SUBMISSION

JANE NEALE, 26 NORMA ROAD, PALM BEACH

3 JUNE 2025

RE: DA 2025/0433
ADDRESS: 24 NORMA ROAD, PALM BEACH
WRITTEN SUBMISSION: LETTER OF OBJECTION
SUBMISSION: TULLOCH

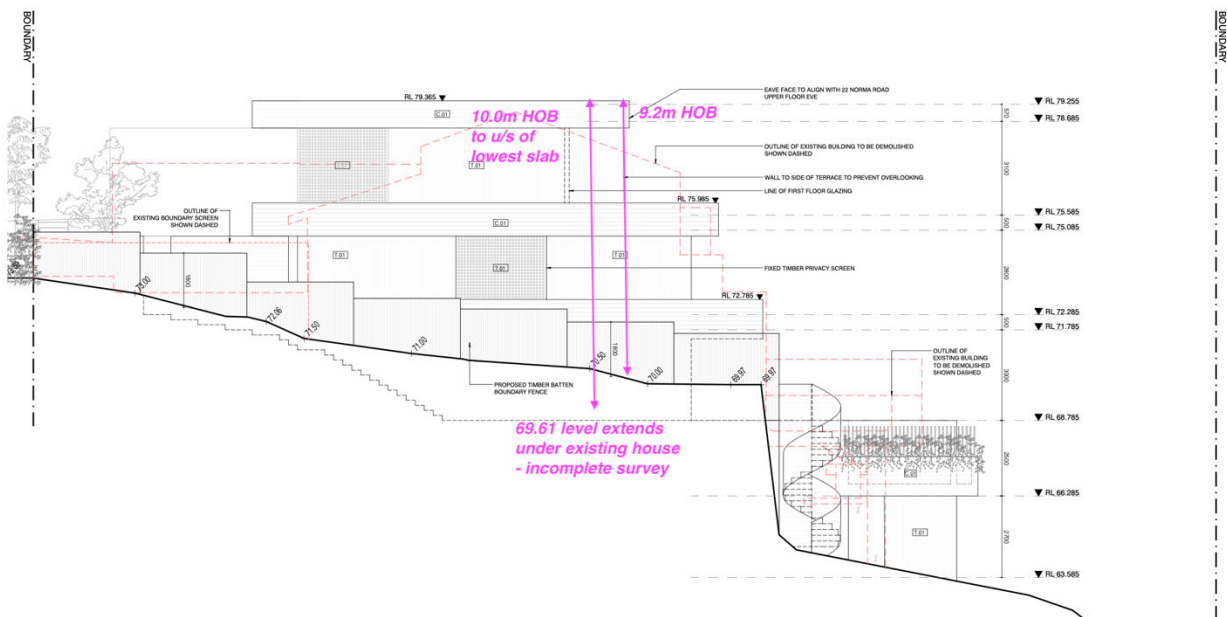
Height of buildings is to be calculated from the *existing ground level* not an extrapolated natural ground level.

Insufficient information has been provided to establish the exact height of building proposed. The ground level of the existing building is not provided on sections.

I contend that *ground level (existing)* on the subject site has not been assessed correctly.
